# **NEN-EN 50604-1/A1 (en)**

Secondary lithium batteries for light EV (electric vehicle) applications - Part 1: General safety requirements and test methods

**EN 50604-1:2016/A1**

This amendment A1 modifies the European Standard EN 50604-1:2016; it was approved by CENELEC on 2021-06-21. CENELEC members are bound to comply with the CEN/CENELEC Internal Regulations which stipulate the conditions for giving this amendment the status of a national standard without any alteration.

**Figure 1 — Example of a removable battery system”***Replace the term entry of 3.31:*

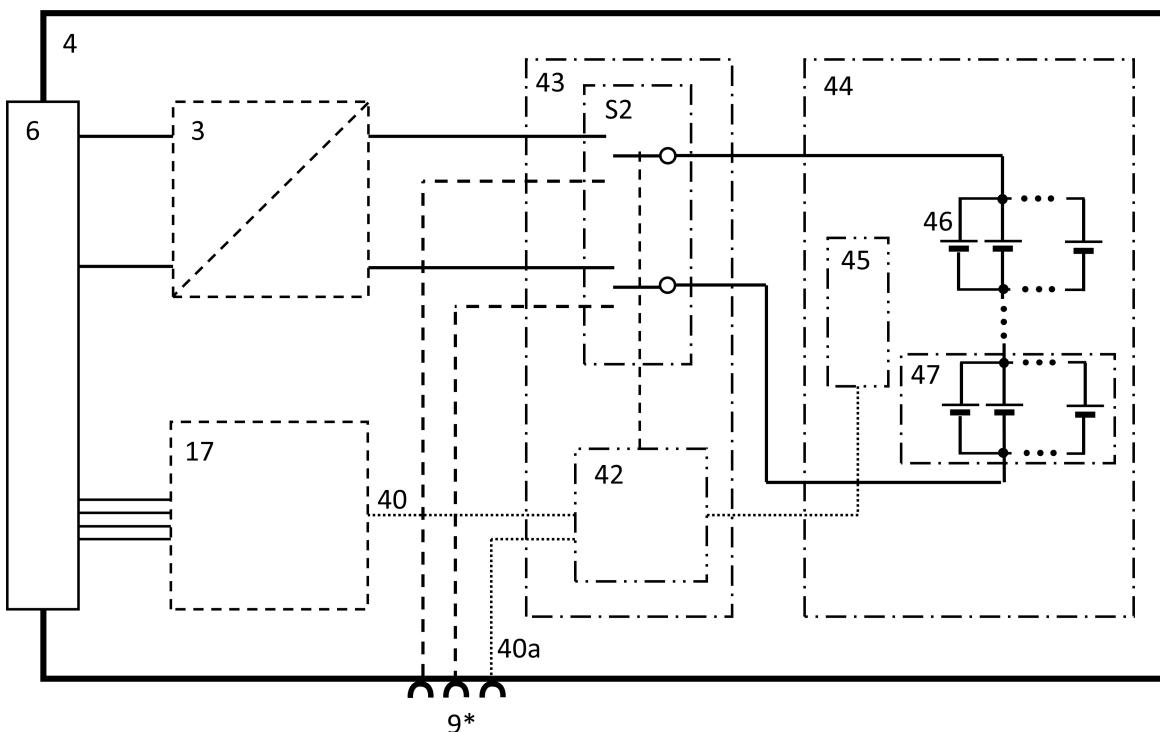
*Add the following figure at the end of 3.18:*

- 3 DC/DC converter for removable battery systems
- 4 Removable battery system
- 6 RESS inlet
- 9\* A/B coupler (optional)
- 17 Gateway
- 40 Manufacturer specific communication circuit
- 42 Protective device(s) (active and/or passive)
- 43 Battery Management System
- 44 Battery Pack
- 45 Sensing and balancing electronics/equipment
- 46 Cells
- 47 Cell block
- S2 Switch
